## REMARKS

## **AMENDMENTS TO THE DRAWINGS**

PROPOSED REPLACEMENT PAGE

Fig. 10

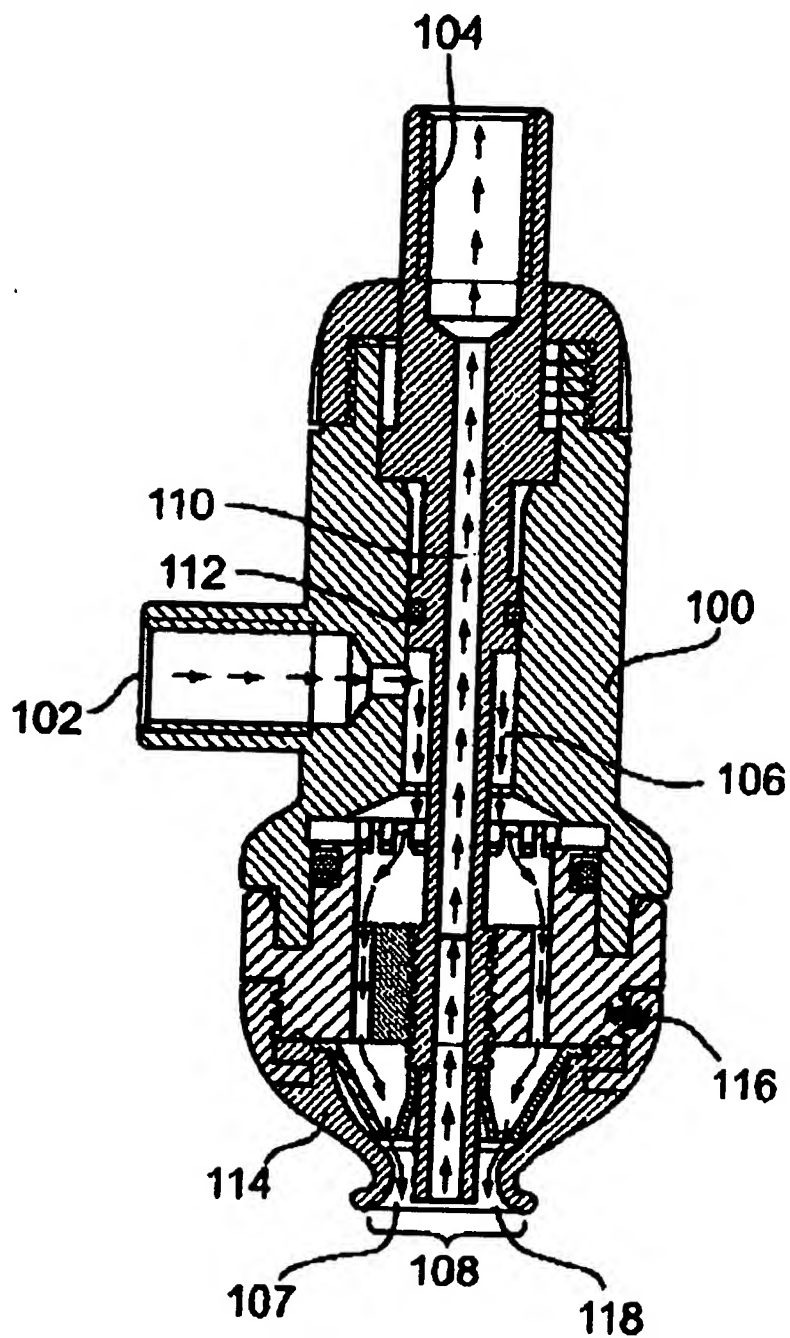
Applicant submits herewith a Proposed Replacement Page for the Examiner's review and approval. This is submitted to correct Fig. 10 of the drawings as shown in red ink. This correction is being made to correct the lead line from reference numeral "116". As it is believed that this correction will be approved, a formal drawing Replacement Page for Fig. 10 embodying this correction is also enclosed.
